TOWN OF TIBURON
1505 Tiburon Boulevard
Tiburon, CA 94920

Design Review Board Meeting
May 19, 2016
Agenda Item: **1**

STAFF REPORT

Subject: 2 Audrey Court; File Nos. DR2015139, VAR2015021 & FAE2015013; Site Plan and Architectural Review for the Construction of Additions to an Existing Single-Family Dwelling, with a Variance for Excess Lot Coverage and a Floor Area Exception (Continued from April 21, 2016)

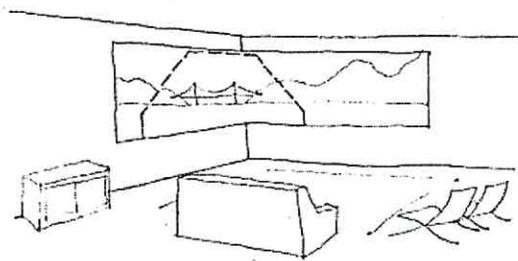
The upper level addition would also be visible from other homes further away and interfere with some views from these locations. As of the date of this report, staff has received additional complaints from the owners of 4 & 8 Bartel Court and 23 & 25 Meadowhill Drive. The addition would block views of the Golden Gate Bridge from the living room of the home at 4 Bartel Court

and extend slightly further into views of San Francisco from the living areas of the homes at 8 Bartel Court and 23 & 25 Meadowhill Drive.
